JOSEPH M. FARLEY NUCLEAR PLANT - UNIT NO. 2
RESPONSE TO QUESTIONS RELATED TO EXECUTIVE ORDER 11988
FLOODPLAIN MANAGEMENT

RESPONSE TO
HYDROLOGIC ENGINEERING GENERIC QUESTIONS
RELATING TO EXECUTIVE ORDER 11988 FLOODPLAIN MANAGEMENT
FOR PLANTS NEAR COMPLETION

P-1(b) AND P-2
UNCONFINED WATER LEVELS
FIGURE 2.4-61

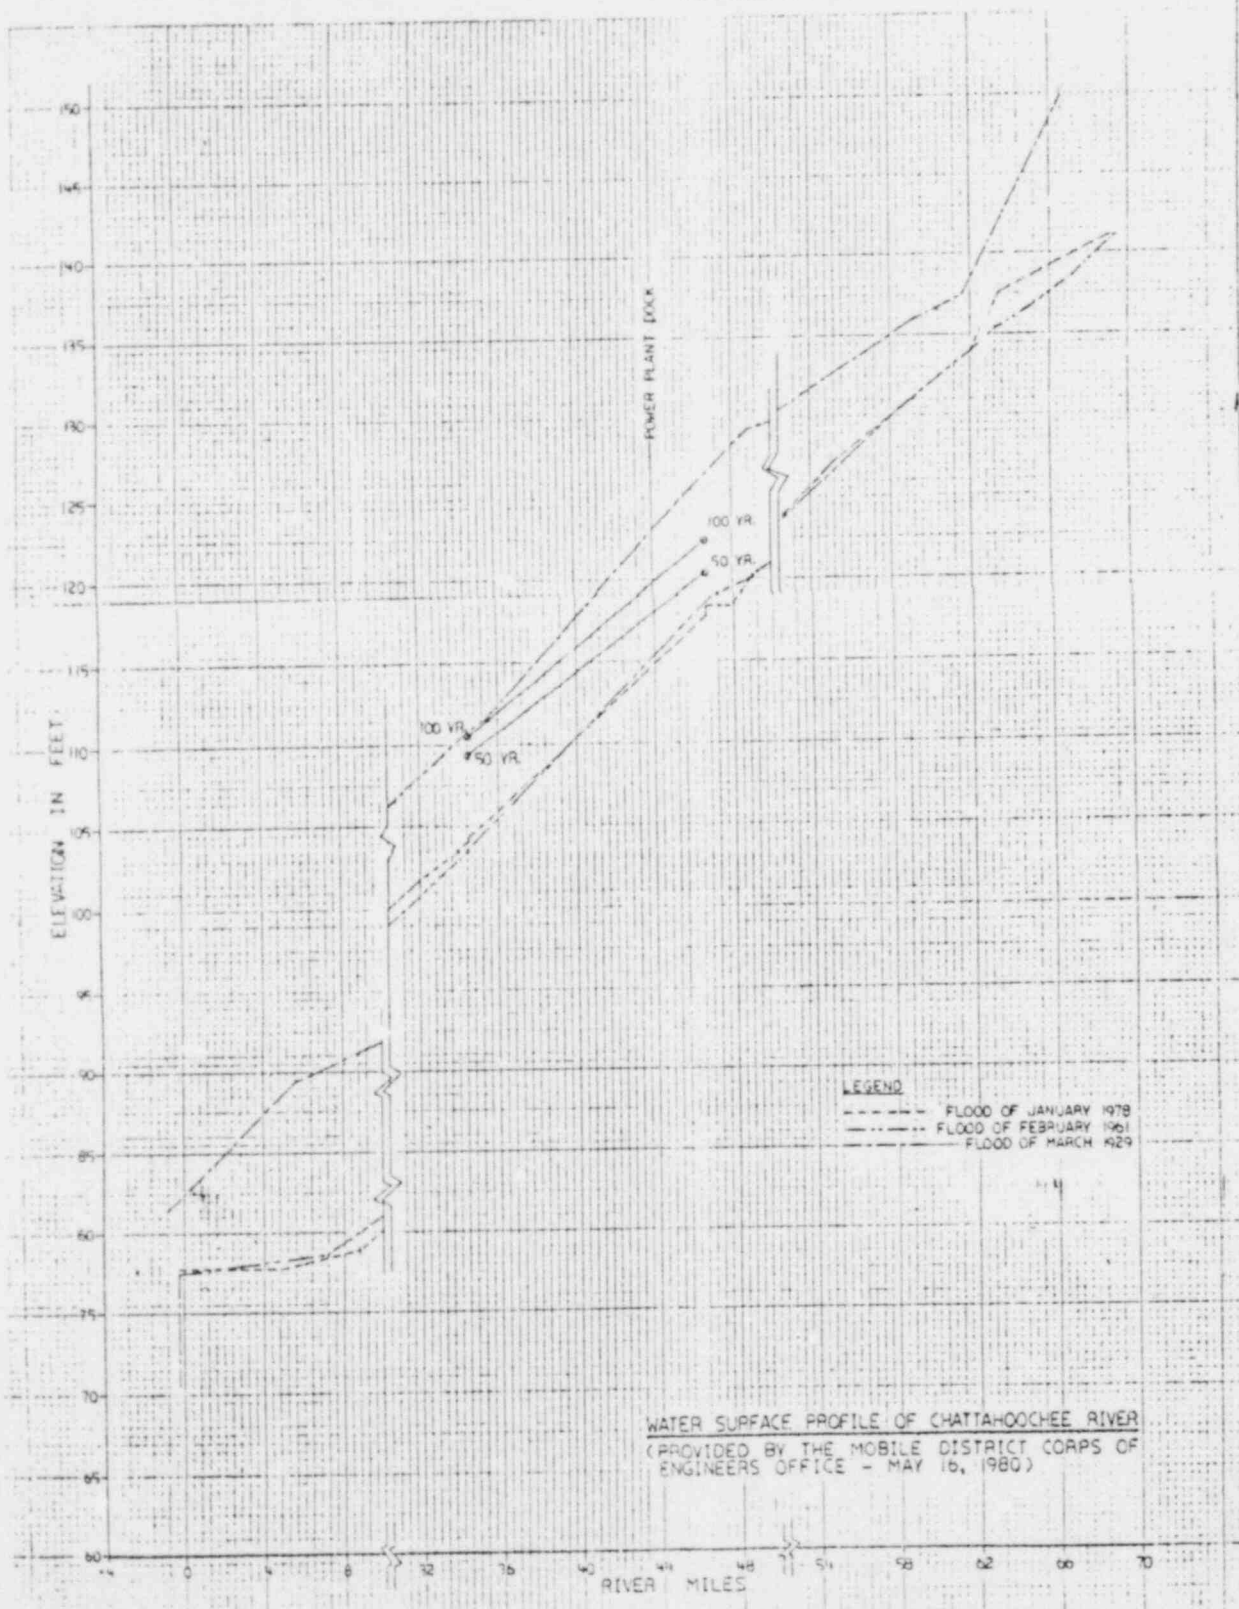
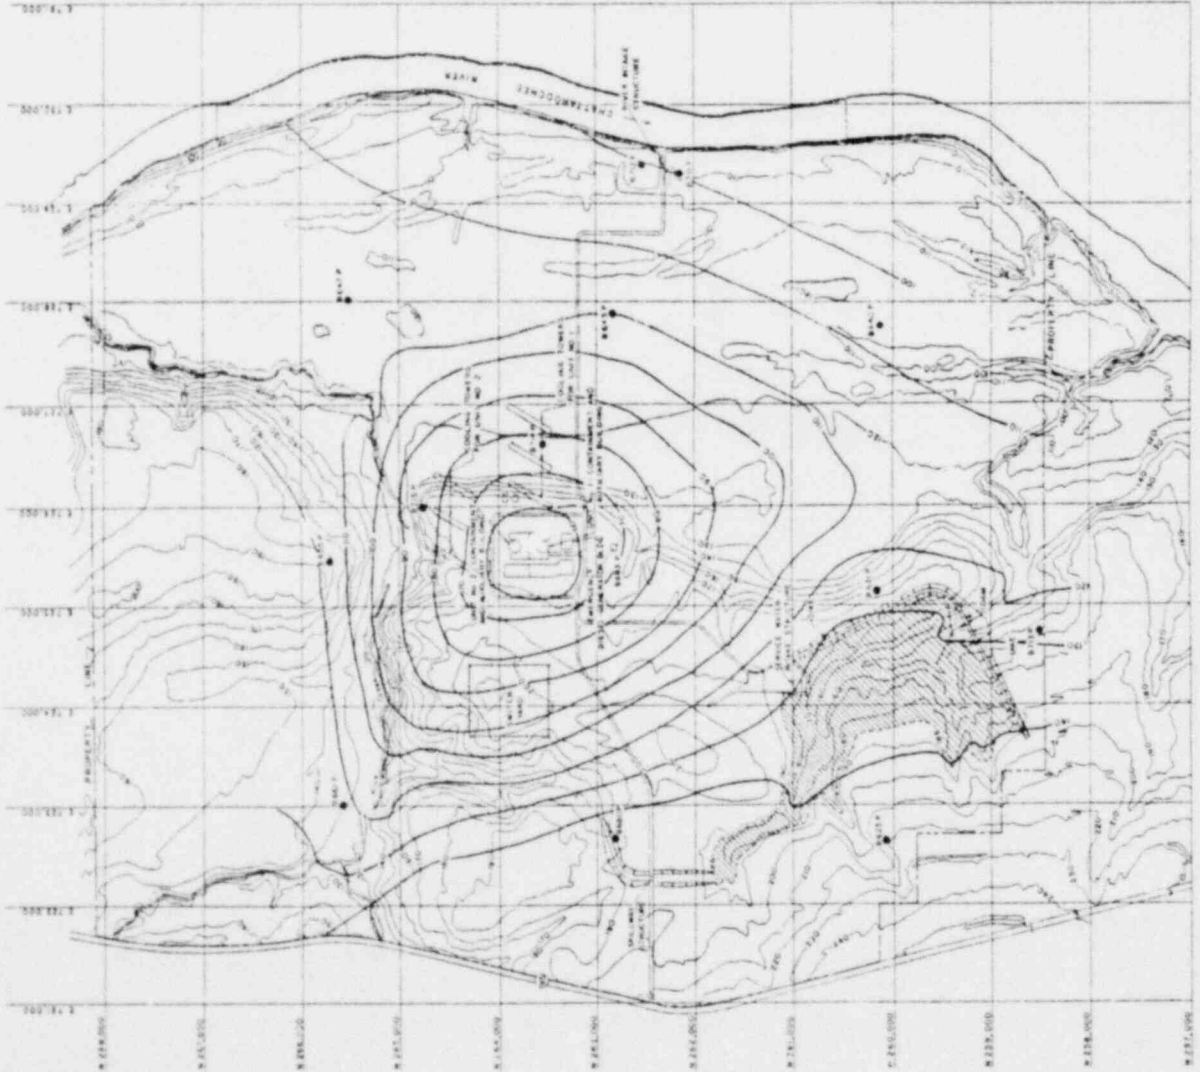
Provide descriptions of the floodplains of all water bodies, including intermittent water courses; within or adjacent to the site. On a suitable scale map provide delineations of those areas that will be flooded during the one-percent chance flood in the absence of plant effects (i.e., pre-construction floodplain).

Provide details of the methods used to determine the floodplains in response to 1. above. Include your assumptions of and bases for the pertinent parameters used in the computation of the one-percent flood flow and water elevation. If studies approved by Flood Insurance Administration (FIA), Housing and Urban Development (HUD) or the Corps of Engineers are available for the site or adjoining area, the details of analyses need not be supplied. You can instead provide the reports from which you obtained the floodplain information.

Joseph M. Farley Nuclear Power Plant is located on the west bank of the Chattahoochee River at River Mile 44.3 and about 15 air miles east of Dothan, Alabama. The plant yard grade is at El. 154.5 feet MSL. One small stream flows across the northern part of the plant boundary while another wet weather stream crosses the southeastern part as shown on attached FSAR Figure 2.4-1. An emergency cooling pond as shown on attached FSAR Figure 2.4-61 with hatched area, is located to the southwest of the plant.

The Corps of Engineers' Mobile district has provided the river water surface profile data for the 100-year flood (profile attached). In the vicinity of the plant, i.e., River Mile 44.3, the 100-year flood elevation is 119.5 feet MSL per the water surface profile provided by the Corps of Engineers. The 119.5 feet MSL contour line is traced on attached FSAR Figures 2.4-1 and 2.4-61 to delineate the flooded area.
